ADDENDUM NUMBER THREE

DARLA MOORE SCHOOL OF BUSINESS CONSTRUCTION – BP-3
ENCLOSURE/SITE/MEFP/INTERIOR
UNIVERSITY OF SOUTH CAROLINA
STATE PROJECT NUMBER H27-6069-AC-3

DATE OF ISSUE: June 22, 2012

EMERGENCY CALL BOX - DETAIL
REF. DWG # A0362

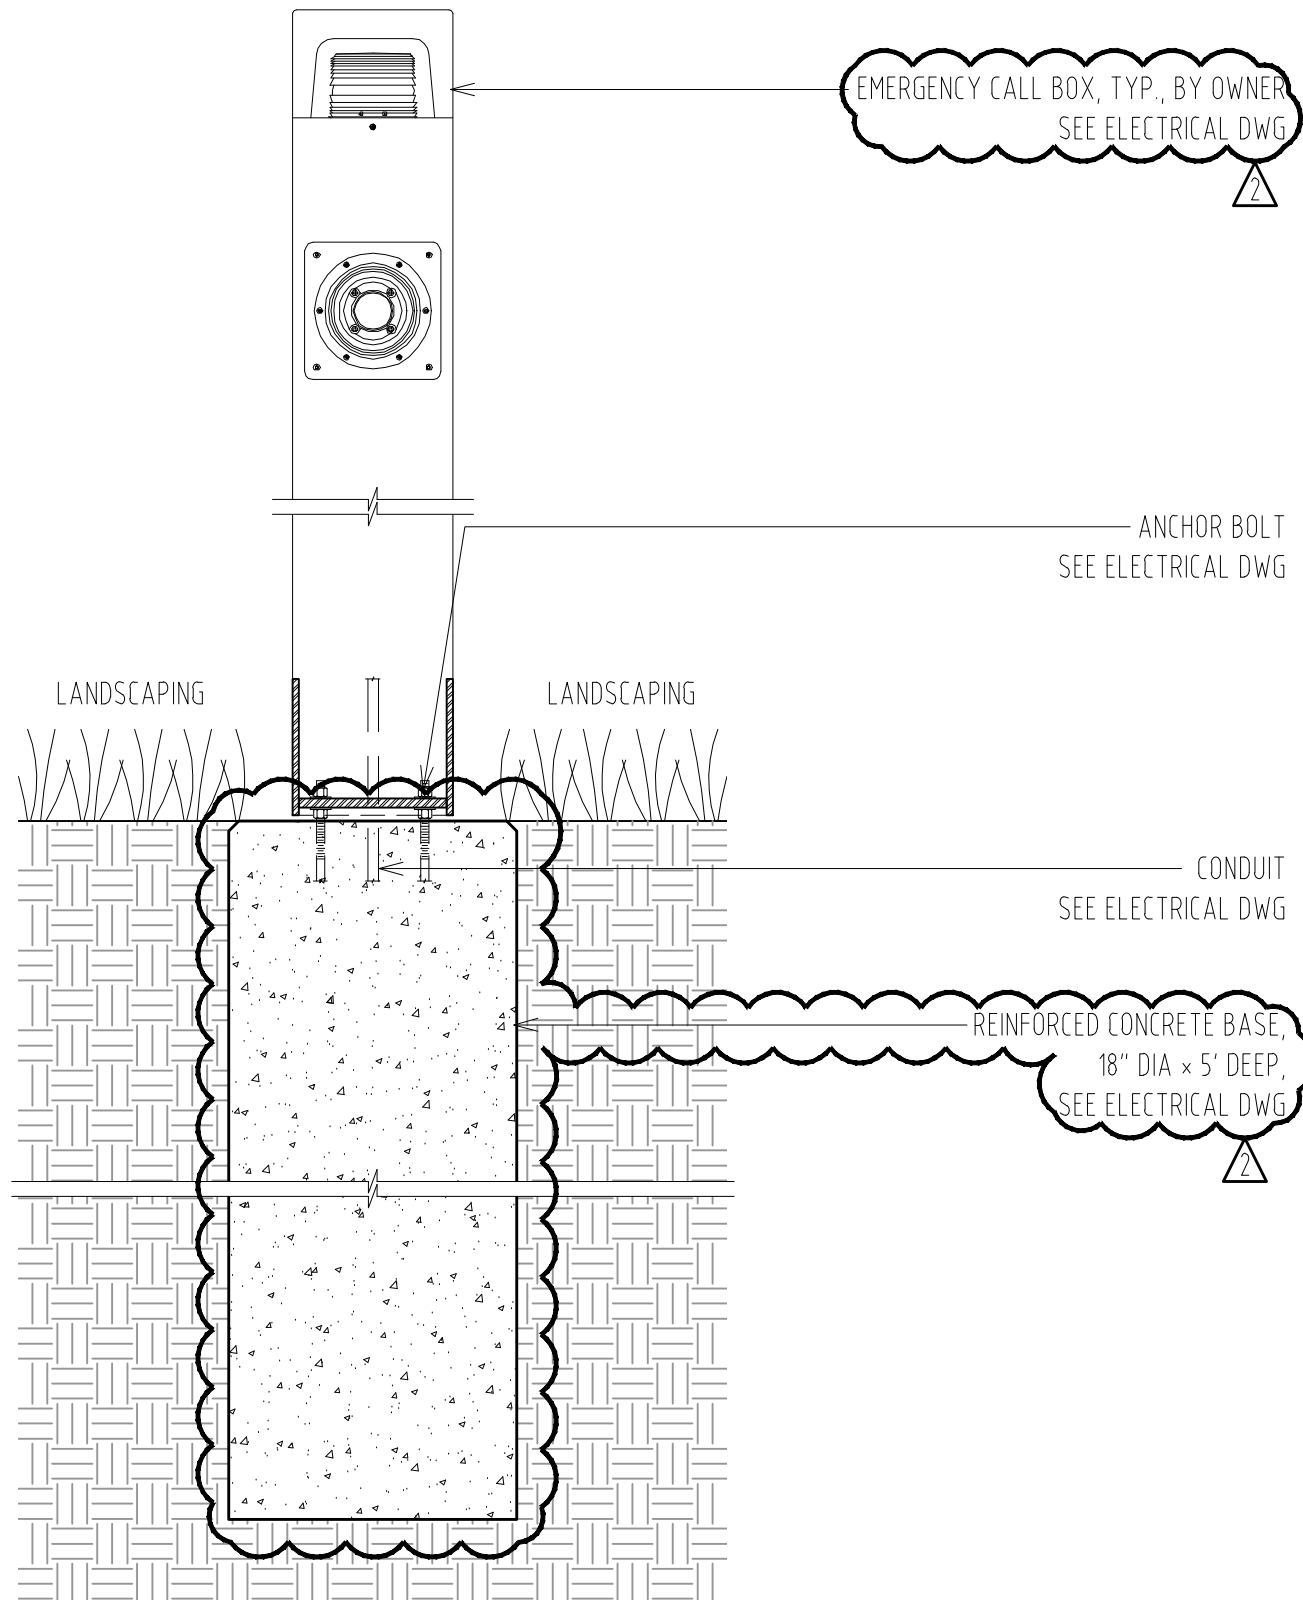
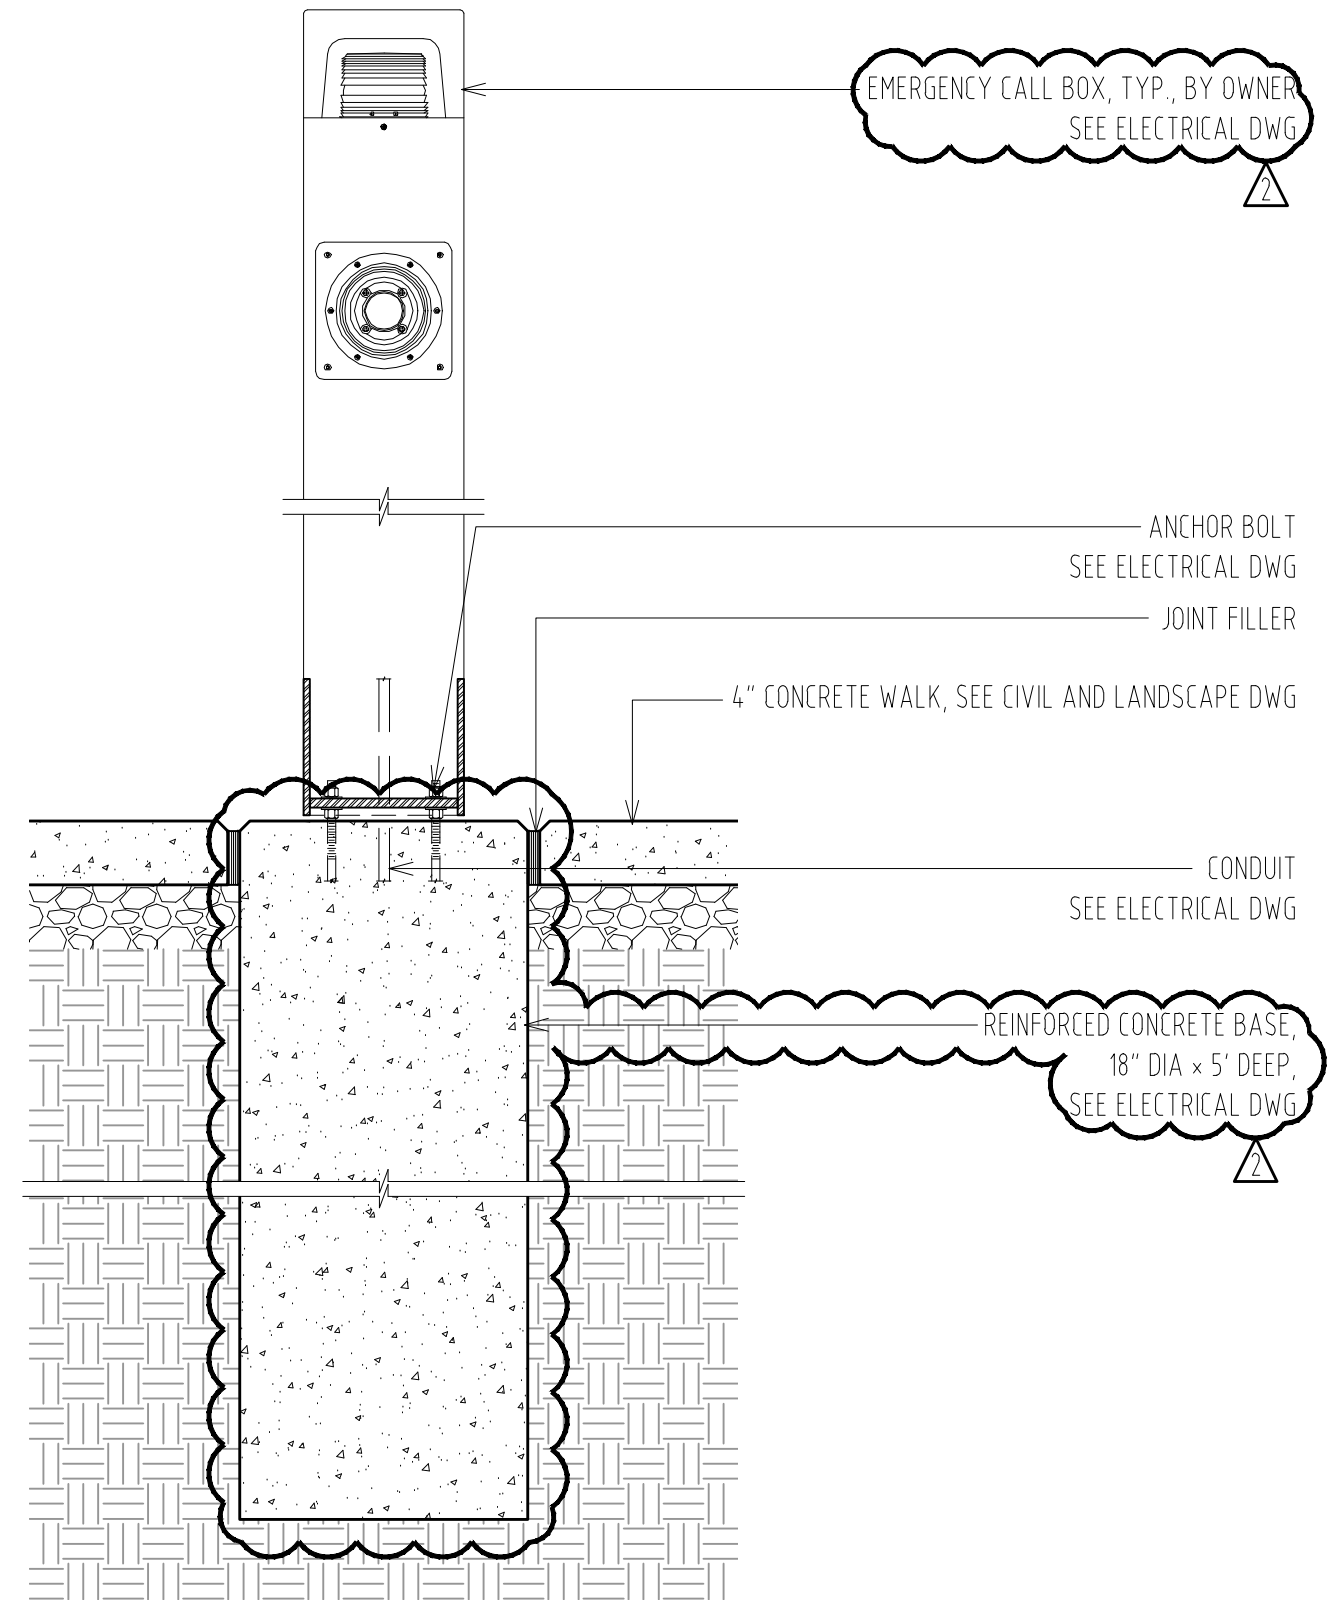
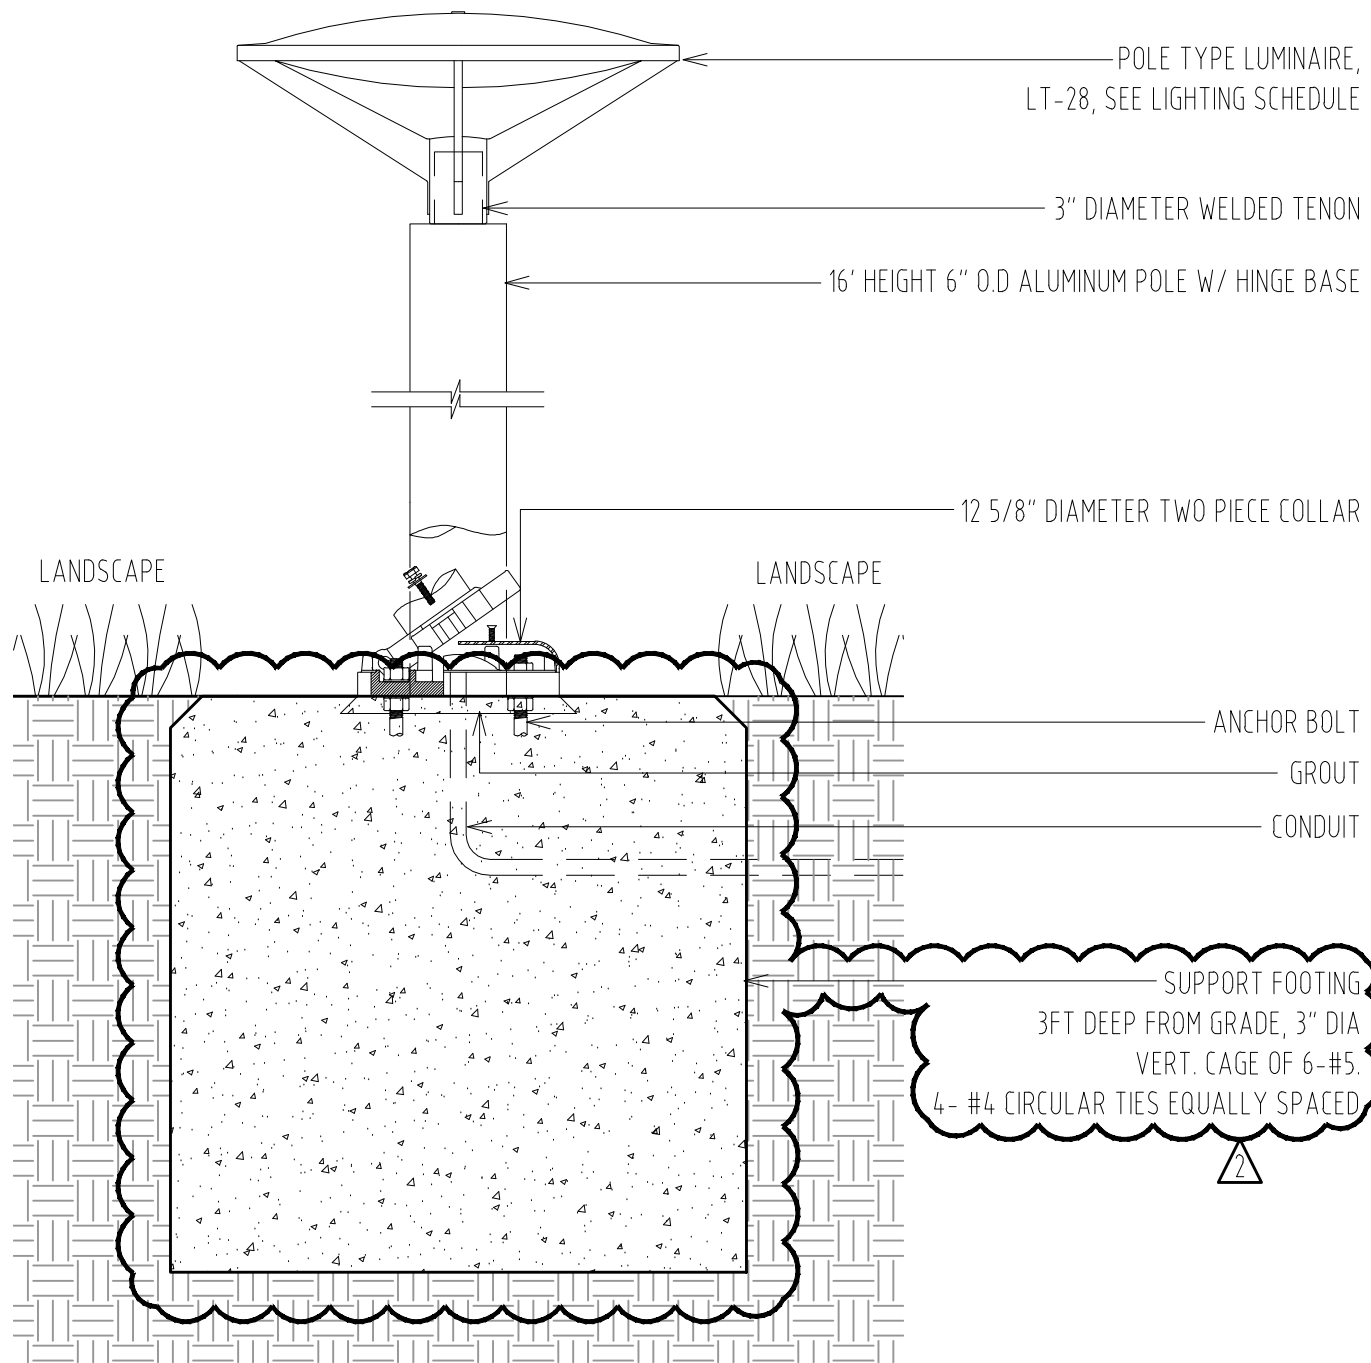
8. Sheet A0323.0: Refer to attached sketch A-SK-060. Structural information – reference added.
9. Sheet A0362: Refer to attached sketch A-SK-061. Base footing revision.
